# REMEDIAL ACTION CONSTRUCTION COMPLETION REPORT

# VOLUME II AS-BUILT DRAWINGS & DESIGN CHANGE FORMS

Pine Street Canal Superfund Site Burlington, Vermont

#### **DESIGN CHANGE FORMS**

Design (	Change N	lumber: (	005	
Major				
Minor	X			
Date of 1	Request:	Septemb	er 10,	2002

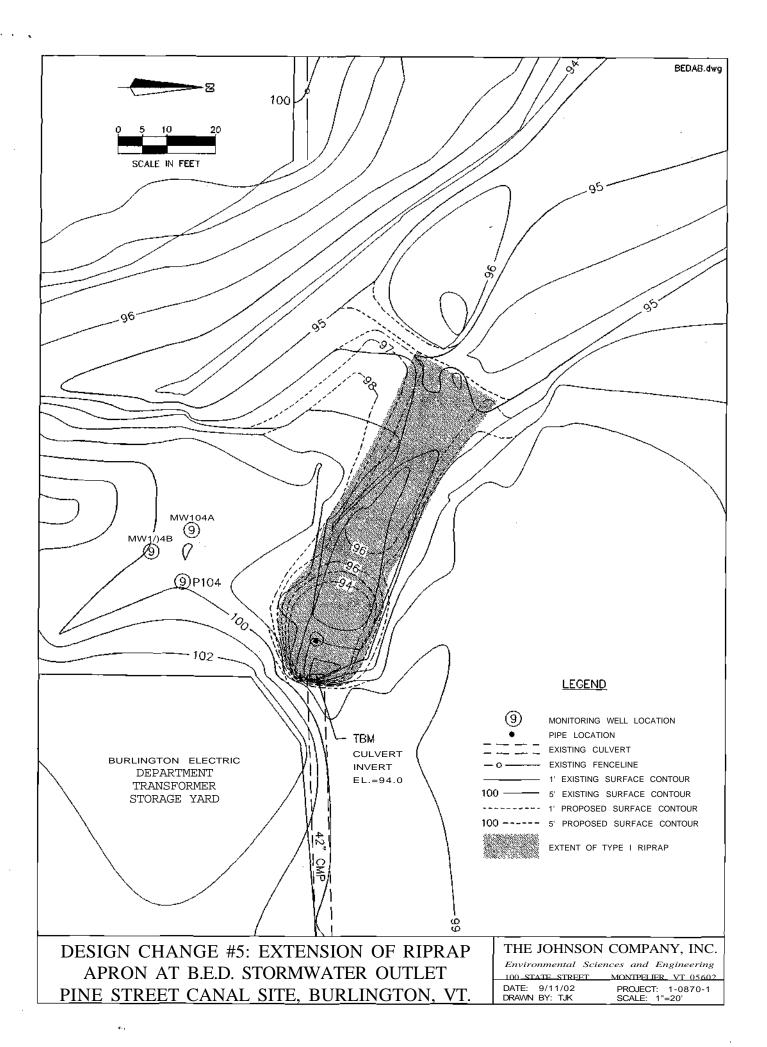
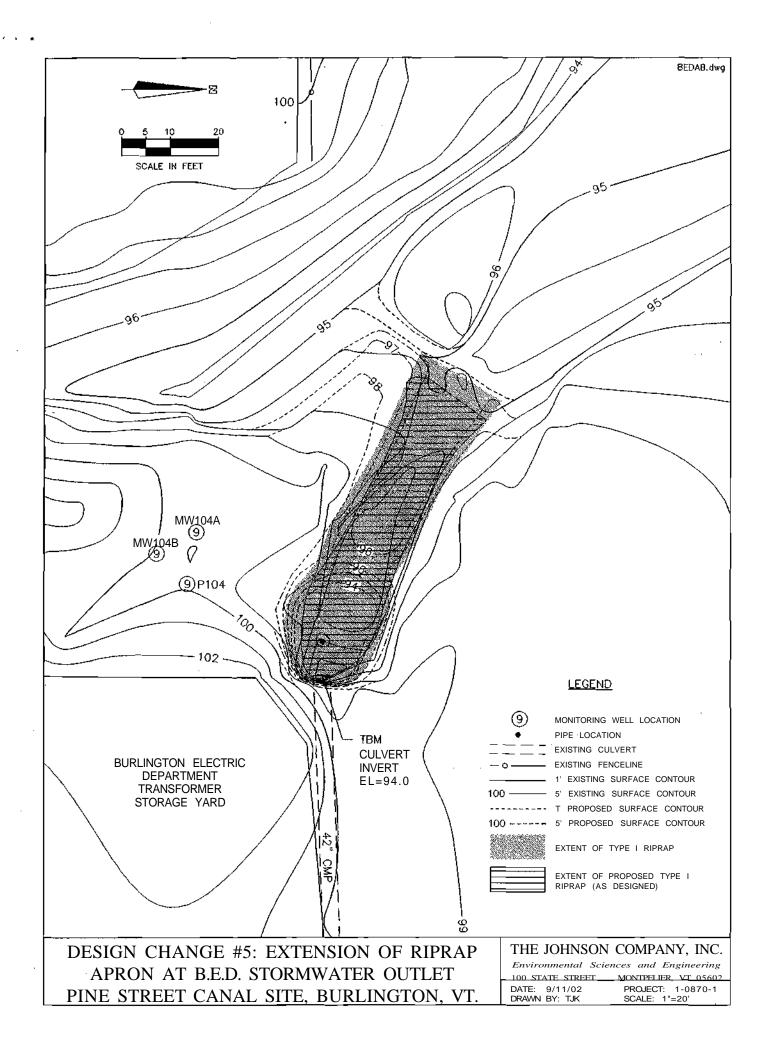
Notification of a Field Change in the geometry of the BED outfall plunge pool apron was provided to de maximus in a single page summary dated August 21,2002. The rip-rap apron geometry needed to be changed due to changes in the existing ground surface topography since 1994, when the area was last surveyed.

Specifically, additional sand and sediments had been naturally deposited at the proposed end of the aptorx, raising the ground surface elevation by more than a foot since 1994. In order to provide a smooth transition between the rip-rap apron and the existing ground surface it was necessary to extend the apron by six feet in a down-gradient direction, and to reduce the slope of the apron surface. It was also necessary to slightly increase the width of the apron in order to maintain the bottom width and side slopes at designed.

These changes will not decrease the sediment removal efficiency of the apron and plunge pool from that in the approved design (see Sheet 8 of 8 - Grading Plans and Details, B.E-D. Stormwater Outlet). Actually, the sediment removal efficiency is likely to be increased by the decreased slope and increased length of the rip-rap apron.

These changes will not reduce the storm-water carrying capacity of the BED culvert from that in the approved design. During design, the BED pipe capacity was calculated for a cross-section across the plunge pool outlet sill (at 96 ft NGVD). This sill is not affected by the proposed design change, and is the primary control for stormwater flow from the BED culvert.

The proposed changes will not significantly affect the wetlands area at the Site. Approximately 0.003 additional acres of rip-rap will be added by the proposed design change.

Plan view contour map of proposed changes and plan comparing approved design and proposed changes.

# DESIGN CHANGE NO.6 - AREA 2 WATERWAY CONCEPTUAL CROSS-SECTION - STATION 2+75

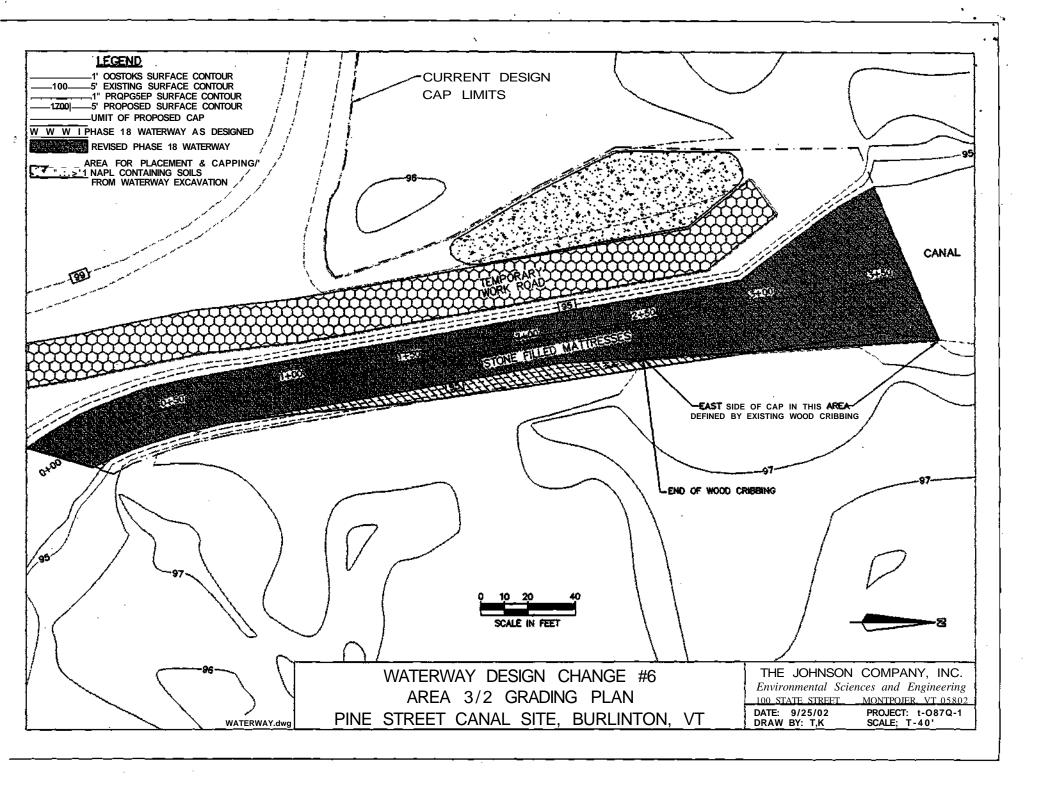
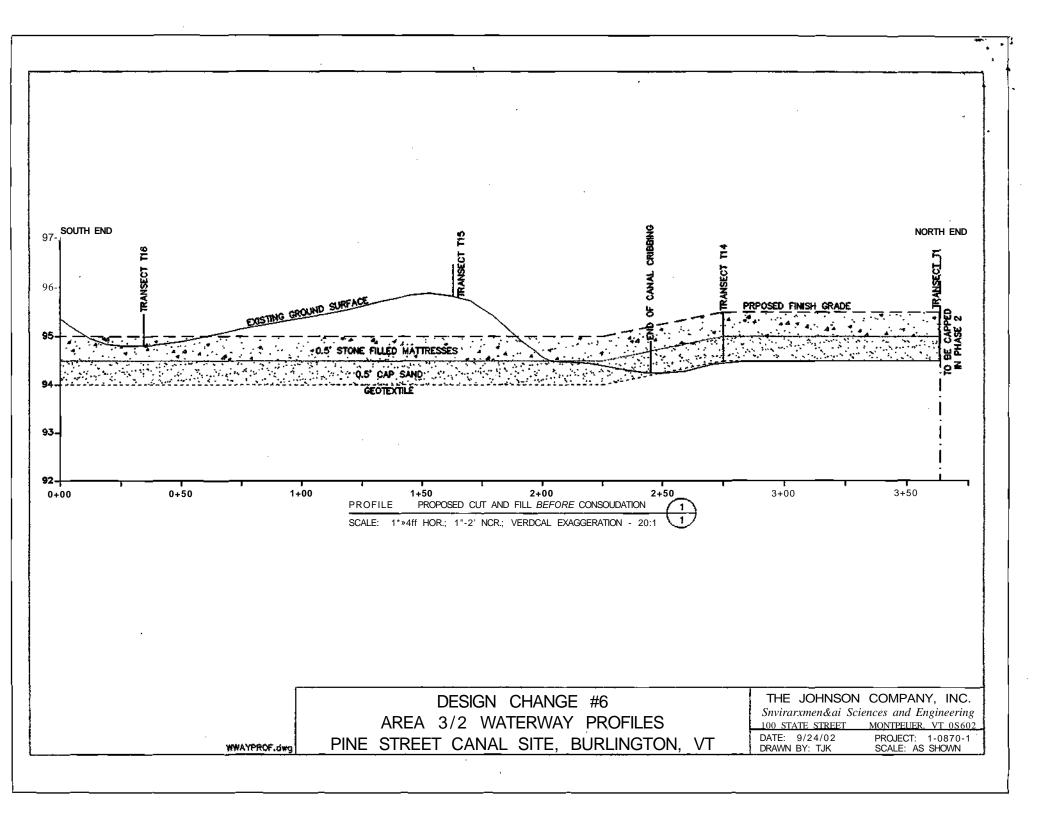
A minor design change for the Area 2 waterway is necessary to accommodate existing field conditions. The design change includes three parts: 1) revise the centerline of the waterway; 2) revise the finished grade of the waterway; and 3) place of a limited quantity (est. 30-50 cubic yards) of non-aqueous phase liquid (NAPL) containing soils within Area 2. The rationale for, details of, and expected consequences of, these changes are provided below.

The proposed design change is to shift the centerline westward approximately 10 feet at Station 2+15 and re-align the waterway to match the cribbing alignment (see attached *Waterway Design Change #6*, *Area 3/2 Grading Plan*). The coir logs used to define the edges of the waterway will extend up to and alongside the cribbing. This is a simple re-alignment of the waterway to meet the field conditions (keep the waterway between the cribbing).

During the layout of the waterway, it was determined that the existing grades at the south end of the waterway had increased about a foot since last surveyed. At the south end of the waterway, the current grades range from elevation 94.9 to 96.3 ft NGVD, as compared with elevations between approximately 93 and 95.3 ft NGVD shown on Sheet 5 of 8 of the approved Design Drawings.

The proposed change is to raise the waterway finished grade before settlement to 95 ft NGVD in order to approximately meet the average existing grade south of the waterway. The north end of the waterway is proposed to be placed on the existing grade with a finished grade at approximately 95.5 (before settlement). This finished grade at the north end will later transition into the Phase 2 cap which will also be placed at the existing grade (elevation 94.5) at the south end of the Phase 2 work. The existing and proposed grades for the waterway are shown on the attached *Design Change #6*, *Area 3/2 Waterway Profile*.

It is proposed that soils with visual evidence of NAPL (e.g. with flowable or blobs of product) will be placed and capped on the west side of the temporary access road in Area 2 (please refer to the stippled area on the attached *Waterway Design Change #6*, *Area 3/2 Grading Plan* for the specific proposed location). The proposal is to move them from one side of the road to a controlled area on the other side. Since the entire area will be capped and the contamination appears to be present at similar depths in Area 2, the inclusion of these minor quantities of NAPL containing soils will not effect the overall performance of the cap.

Map comparing approved design and proposed changes: Waterway Design Change #6, Area 3/2 Grading Plan Profiles of limits of excavation and expected consolidation: Design Change #6, Area 3/2 Waterway Profile

DE 8 GN CHANGE #6.: ARE A 3/2 W A TERWAY

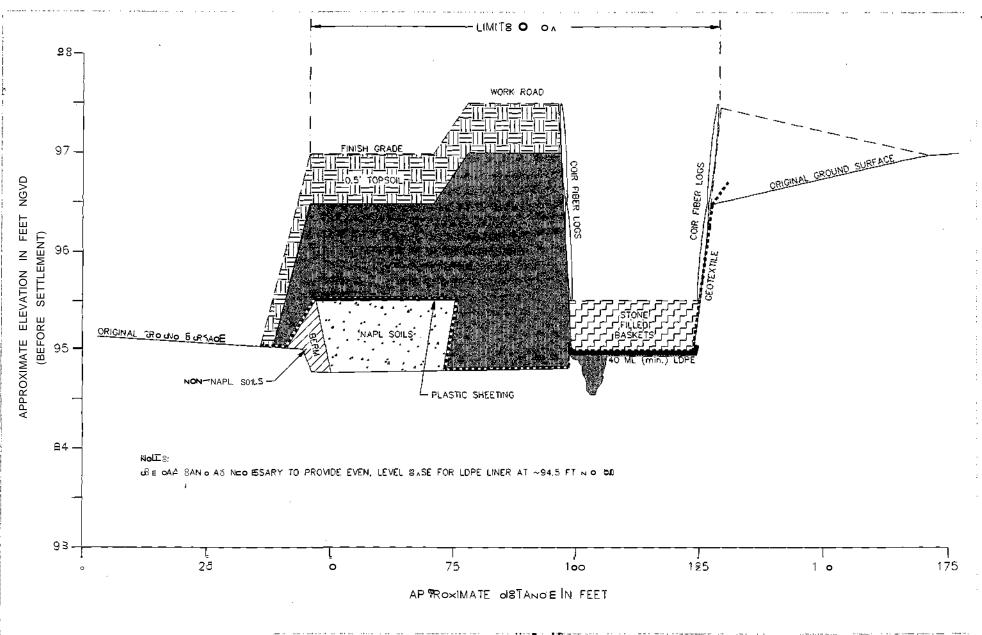
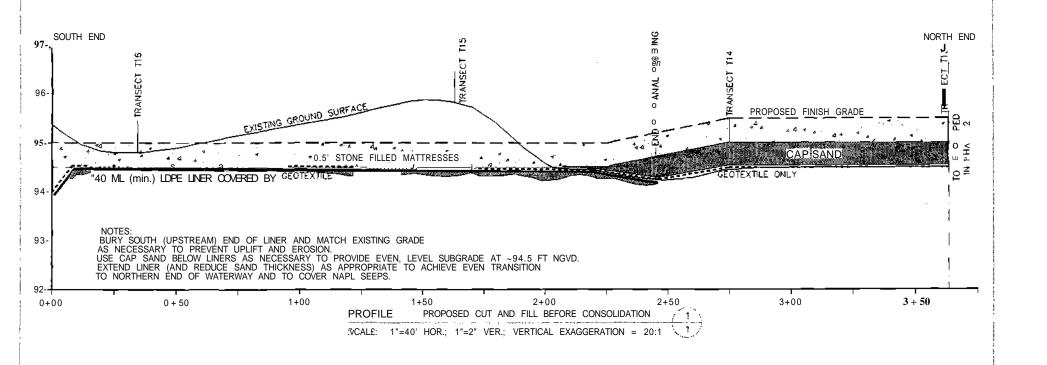
It is proposed that the six-inch thick sand bed below the stone-filled mattresses be eliminated between approximately Stations 0+00 and 2+50, and replaced with a 40 ml (minimum thickness) low density polyethylene liner. The newly proposed subgrade elevation will be at 94.5 ft NGVD. Any existing low areas (below 94.5 ft NGVD) will be filled with cap sand. The liner will be placed on the subgrade, covered with geotextile, and the mattresses placed on top. Please refer to the attached *Design Change #6A*, *Area 3/2 Waterway Profile* and *Design Change Waterway Profile* and *Des* Change #6A, Area 3/2 Waterway Cross Section at Station 2+50 for details.

This change will reduce the volume of NAPL contaminated soils which must be excavated. The proposed change will not change the design final grade (before consolidation) of the waterway, and so will not affect its hydraulic capacity. The safety factor against erosion of the waterway will also be unchanged.

As shown on the attached Grading Plan and Profile, Station 2+50 marks the approximate southern extent of where the Canal was formerly dredged. The proposed design change includes the use of the plastic liner between Stations 0+00 to approximately 2+50 (plus or minus 25 feet). However, the proposed change also allows extensions of the area where the plastic liner replaces the sand bedding as necessary based upon field conditions to promote an even transition to the remaining portion of the waterway and to cover locations with visually observed NAPL seeps.

ATTACHMENTS: (list supporting documentation, if applicable)
Design Change #6A, Area 3/2 Waterway Profile
Design Change #6A, Area 3/2 Waterway Cross Section at Station 2+50 Waterway Design Change #6, Area 3/2 Grading Plan from Design Change 6 dated September 30, 2002 and Revised October 2

Cross Sections of Area 2 Waterway at Transect T14+00 (Station2+65), Design Change 6B Area 2 Waterway Site Plan, North End, Design Change 6B

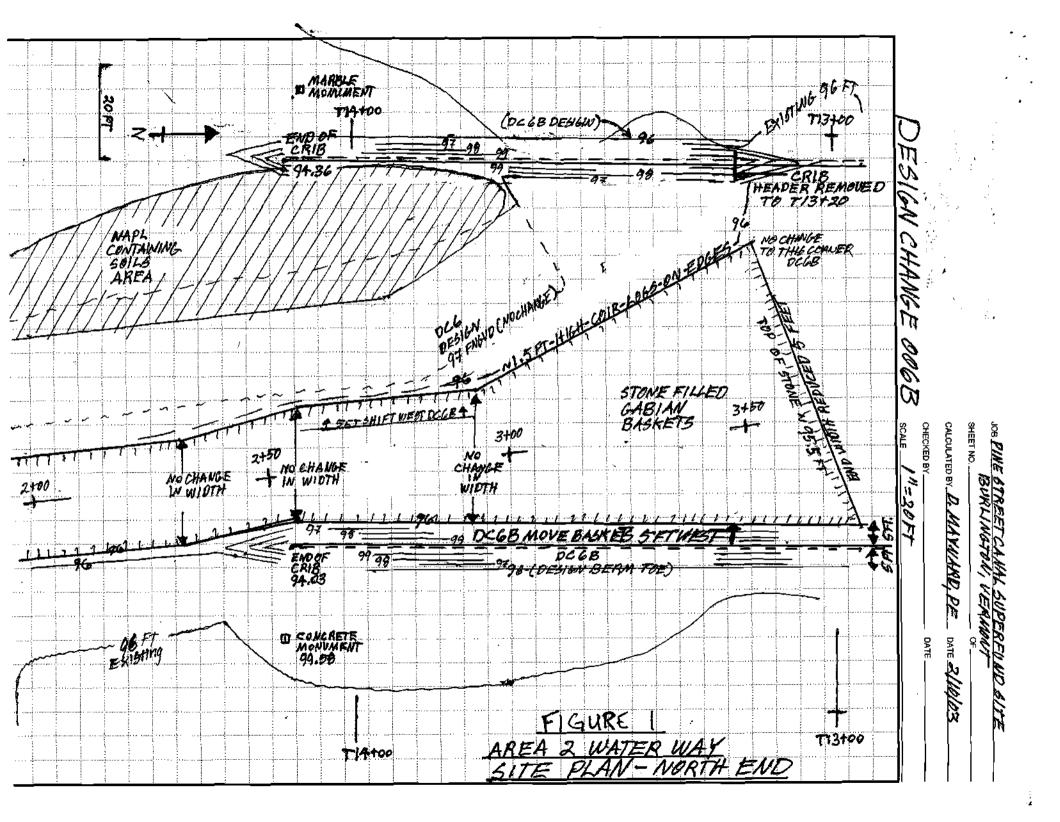
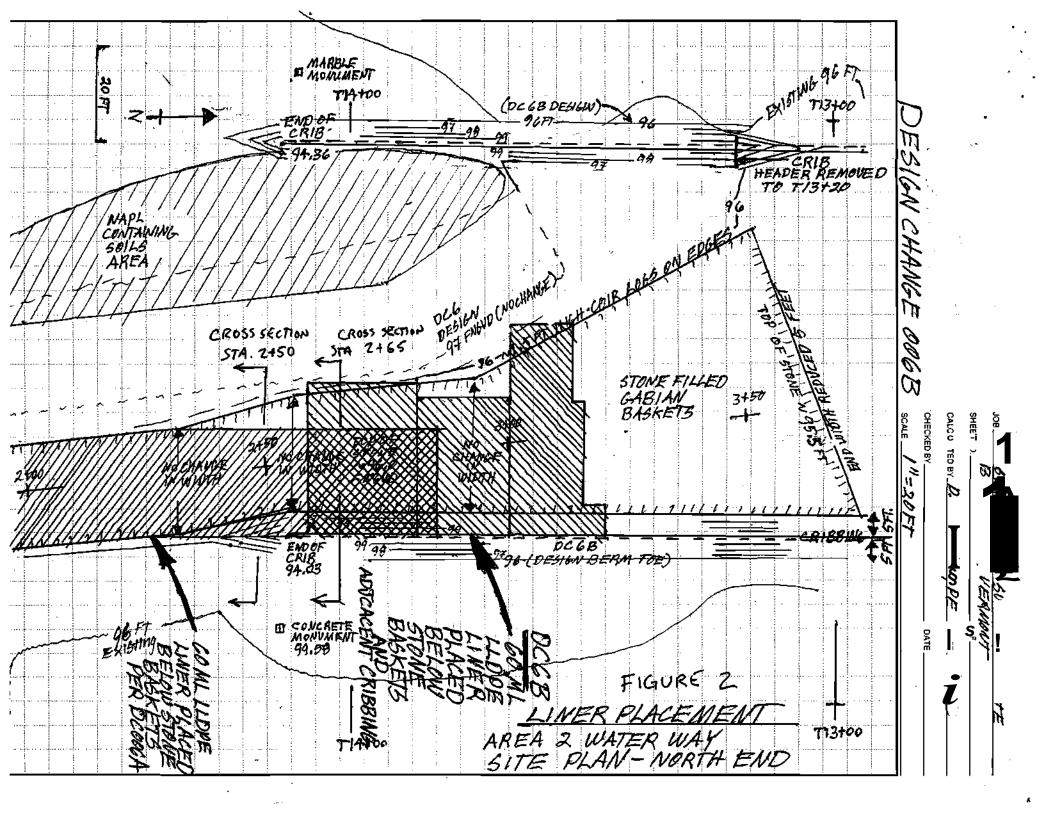
To address the concern of the rock baskets near the cribbing pathway, this design change proposes to re-locate the Area 2 waterway five feet westwards from its current design location (without changing its overall width). The change will affect the Area 2 waterway from approximately centerline Stations 2+25 to 3+60 (see attached plan on Figure 1). In addition, this design change proposes placement of an additional 60 mil LDPE liner over to the east cribbing.

To address the concern of removing the buried cribbing header, a revised treatment of the top of the east and west cribbing where the header beam is at or beneath the sediment surface is proposed. This revised treatment involves placement of sufficient cap sand (approximately five feet) over the cribbing to prevent any upward migration of sediment via the cribbing walls, without removing the header beam (see attached cross-sections on Figure 3 and 4). This sand berm would extend five feet past both sides of the cribbing (and in places on the east cribbing, extends onto the LDPE liner - see attached plan) in order to provide sufficient cap thickness in all directions from the cribbing (at least 1.5 feet).

Potential erosion of the waterway and berm was considered for this JDesjgn Change. The proposed edges of the waterway have generally smoothly curved sides, and are unlikely to erode given the presence of the coir logs and vegetation plantings included in the design. The previous design widths will be maintained, with the exception of the width of the fan at the northern end, which will decrease by five feet. This decrease will not affect the erosion resistance of the waterway, as the purpose of the fan is to disperse the water evenly onto the sand cap, and its width is much larger than the channel portion of the waterway.

Design Change #7, prop Inlet Detail

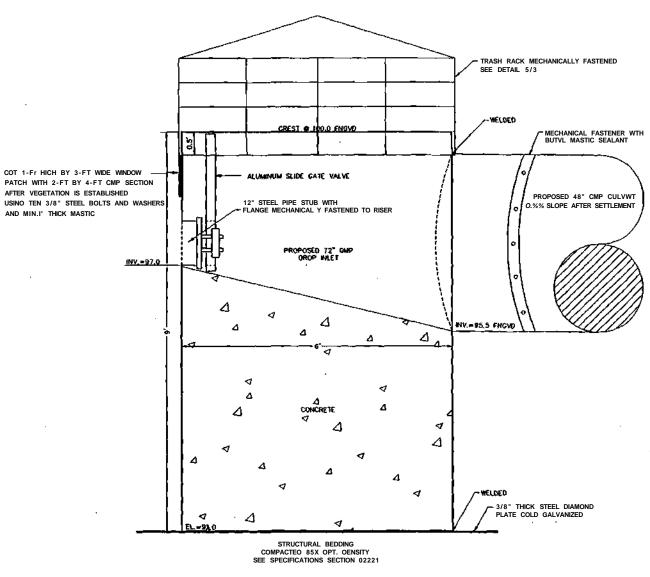
A minor design change for the North Road drop inlet is necessary to allow germination of the seeds in Aree, in the event of a significant precipitation event. The six-foot diameter drop inlet, as designed and installed, inc in level crest at 100.0 ft NGVD and a 12-inch diameter drain set with an invert of 97 ft NCiVD (please refer to ". • ... 2 on Sheet 2 of 8 in the approved Design Drawings). Recent precipitation events (such as the 2.2 inches of r;..i: ^ .. September 27) resulted in Area 7 water levels temporarily rising to elevations of 100,5 ft NGVD or above, if auv';; an event occurred after the Area 7 wetlands had been seeded, but before germination, the seeds would likely fl:offt away.

The proposed change is to cut a window in the drop inlet to allow storm water to by-pass Area 7 while  $tmint;uix:<_{st}$  the increase in water level. The window will be one foot high, and throe fed wide, and will be cut on the soiv, 1 (up-stream) side of the drop inlet (please refer to the attached  $Design\ Change\ \#7$ ,  $Drop\ Inlet\ Detail$ ). The wr. 2; we invert will be at 98.5 ft NGVP, This will provide a minimum of six inches of galvanized metal pipe abo-vs < •'. bislow the window (o maintain the structural integrity of the drop inlet.
